Model 394

Starter device

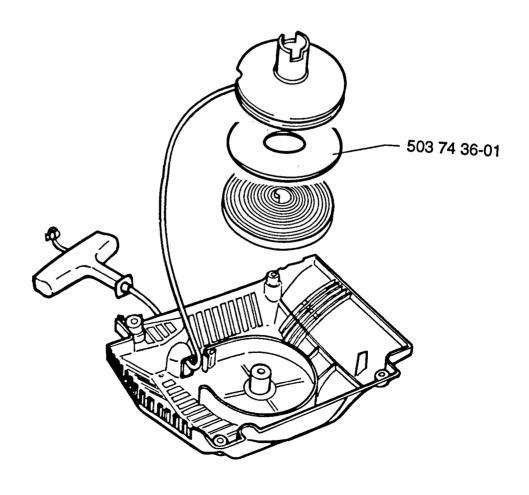
A dirt repelling disc is introduced in the starter device. The disc is mounted between the pulley and the return spring. At the same time the post for the return spring is shortened by 11 mm. The changed starter housing is marked with the casting code "S".

NOTE! If the disc is mounted in starter housings of older design, the post for the return spring must be shortened by 11 mm.
